# United States Patent and Trademark Office

APPLICATION NO.	FILING DATE	FIRST NAMED INVENTOR	ATTORNEY DOCKET NO.	CONFIRMATION NO	
10/646,643	08/22/2003	George William Dailey	2003P07970 US	9785	
7590 03/02/2006			EXAM	EXAMINER	
Elsa Keller			AYRES, TIMOTHY MICHAEL		
Siemens Corpor	ration				
Intellectual Property Department			ART UNIT	PAPER NUMBER	
170 Wood Avenue South			3637		
Iselin, NJ 08830			DATE MAILED: 03/02/2006

Application No.	Applicant(s)				
	10/646,643	DAILEY, GEORGE WILLIAM				
Office Action Summary	Examiner	Art Unit				
	Timothy M. Ayres	3637				
The MAILING DATE of this communication appears on the cover sheet with the correspondence address Period for Reply						
A SHORTENED STATUTORY PERIOD FOR REPLY THE MAILING DATE OF THIS COMMUNICATION.  - Extensions of time may be available under the provisions of 37 CFR 1.13 after SIX (6) MONTHS from the mailing date of this communication.  - If the period for reply specified above is less than thirty (30) days, a reply - If NO period for reply is specified above, the maximum statutory period we - Failure to reply within the set or extended period for reply will, by statute, Any reply received by the Office later than three

King '373 Figure 6

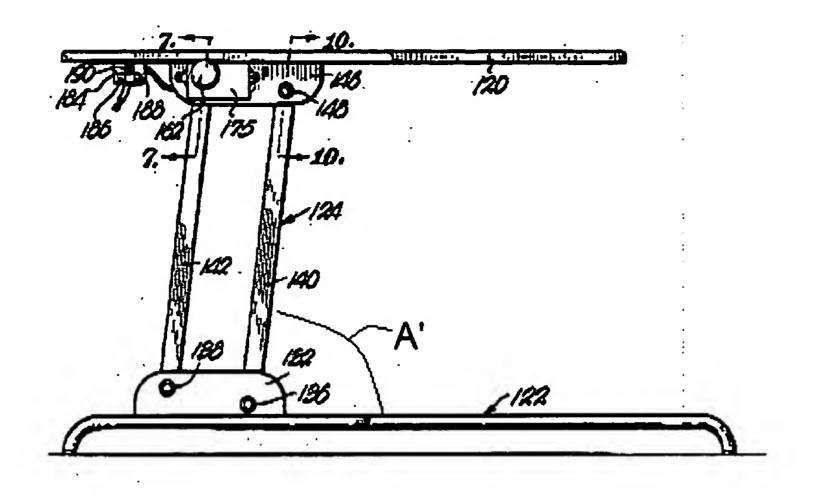
- 7. Claims 1-3 and 8 are rejected under 35 U.S.C. 102(b) as anticipated by or, in the alternative, under 35 U.S.C. 103(a) as obvious over U.S. Patent 3,203,373 to King. King '373 discloses an elongated planar member (120) that has a top and bottom side and inherently can support a patient. A support assembly () includes a base (122) that defines the base plane and a pedestal (132) disposed on the base (122). A plurality of elongated connecting arms (124), with a first end defined by shafts (148,150) and a second end defined by shafts (138, 136). The first end of the elongated members (124) is pivotally attached through shafts (148,150) to the bottom of the planar member (120)

through flanges (146,144). The second end of the elongated members (124) is pivotally attached through shafts (138,136) to the base pedestal (132). The elongated arms (124) each create an angle (A') with the plane of the base (122) as seen in the marked up figure 6. The elongated connecting arms (124) are arranged as a four bar linkage.

- 9. The means for moving the planar member from the first position to the second position is a motor assembly (178) with a worm (182) that contacts a worm gear (155) that imparts rotation to shaft (150) and the links (142) attached to the shaft (150). The plane of the first position and the plane of the second position are parallel to each other and the base plane as shown in figure 1.

- 10. In normal operation the angle (A') goes from an acute angle of approximately zero in a first position (collapsed) to the angle of almost 90 degrees as shown in figure 6 that give maximum height. Though a second position with an obtuse angle is not disclosed, the structure is inherently capable of traveling to an obtuse angle and nothing in the specification teaches nor suggests any reason why an obtuse angle can't or shouldn't be reached. Alternatively it would have been obvious for a person of ordinary skill to use the structure of King to travel from form a first position of an acute angle to an second position of an obtuse angle.
